ITB-OBS-ROOF REPLACEMENT UCC LEARNING COMMONS & LIBRARY

Invitation to Bid (ITB) Mandatory Pre-Bid Conference Meeting Notes and Reference Photographs

3. Chiller

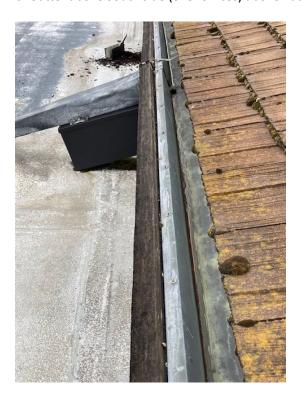
- b. UCC Responsibilities high center section of flat roof:
 - i. Fabricate and install a parapet bracing.
 - ii. Provide weight of the chiller. 4,130 pounds; see attachment.

- ii. Lifting chiller to place membrane under it.
- 5. UCC Crew and Bidders viewed the flat roof above the offices and bathrooms (North and South side).

6. Gutter above South side (over offices) above flat roof.

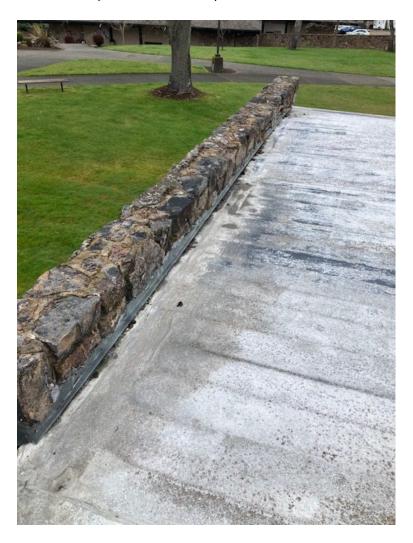
- a. Gutters to be replaced prior to roofing.
 - b. UCC Responsibilities North/South side flat roof:
 - i. Prepare the parapet rock for the roofer to run a membrane up and over-
